City of Gonzales

ADDENDUM NO. 3 Industrial Sewer Collection System Project 07-30-2024

Manhole 20: shown on detail 1/D-5

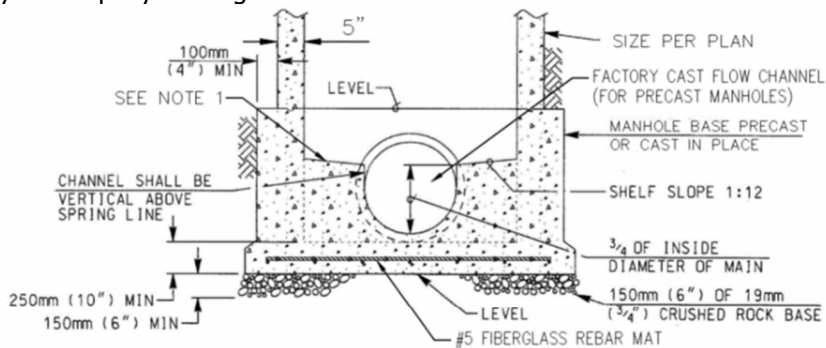
- c. *Question:* Please provide RIM's and Inverts for manholes 19 and 20.

Answer:

Manhole 19:

RIM = 128.63'

INV OUT = 120.92'

INV IN = 121.12'

RIM = 128.5' - 129' +/-

NEW 12" OUT = 121.17'

*per the contract docs, rim elevations for these two manholes are approximate
